ADDENDUM NUMBER ONE

WALK-IN COOLER AND FREEZER REPLACEMENT

SANTEE SCHOOL DISTRICT

BID #1920-090-001

Customer Name: XCE COOLERS		
Project Name: SANTEEV SCHOOL DISTRICT, LOS ANGELES, CA		P.O#:
Drawn By: EPM	Checked By: MG	DRW No: Q
Scale: 3/16" = 1'	Created: 10/2/19	Sheet No: 1 OF 5

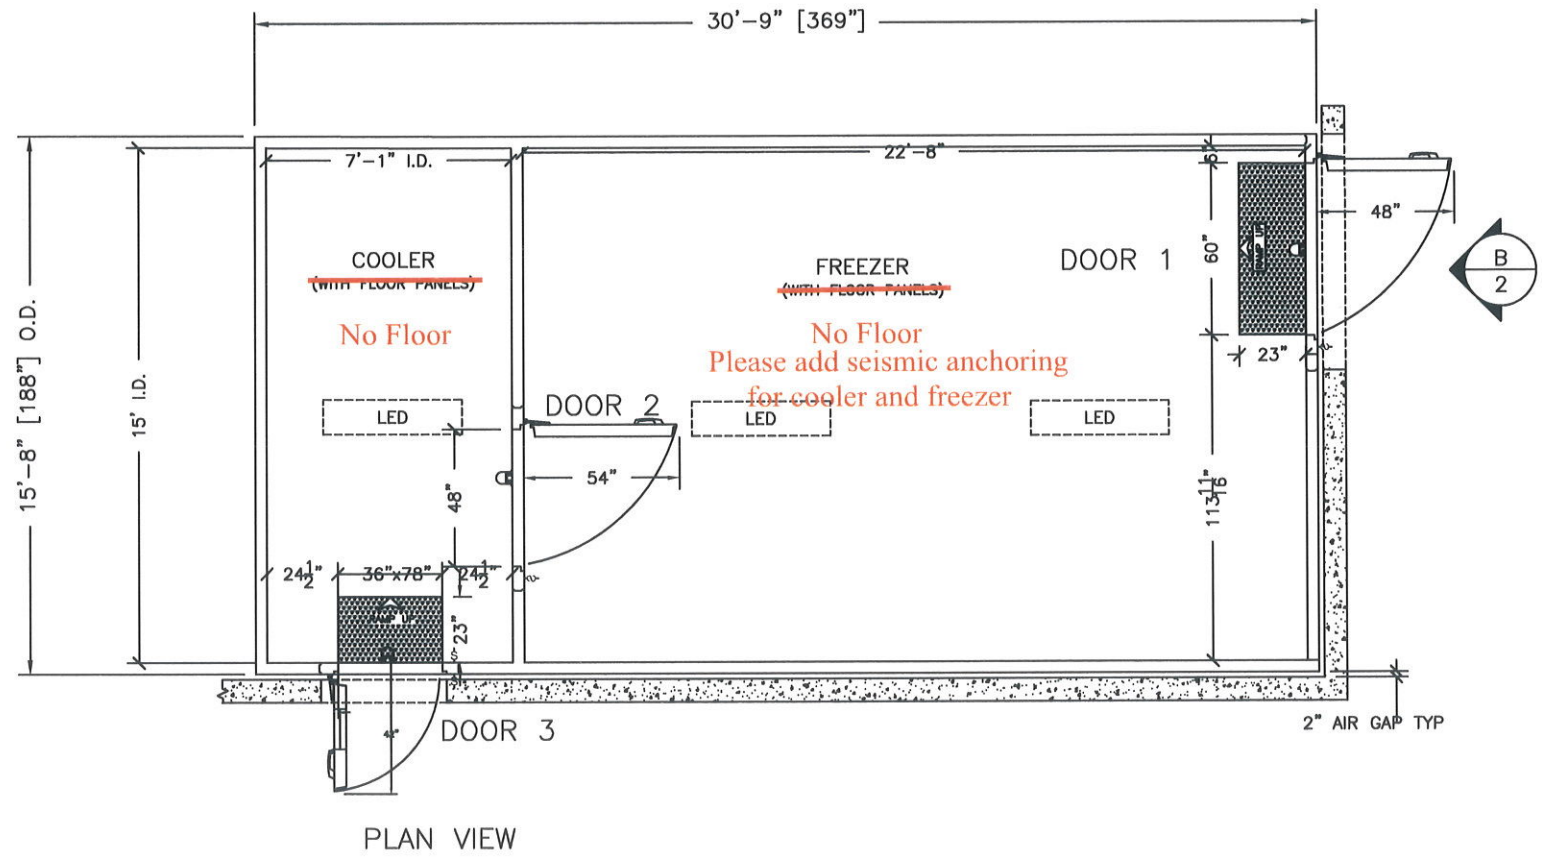
A) **Replace Plans Sheet 1 of 5 with attached Revised Sheet No. 1 of 5, which states “No Floor. Please add seismic anchoring for cooler and freezer”.**
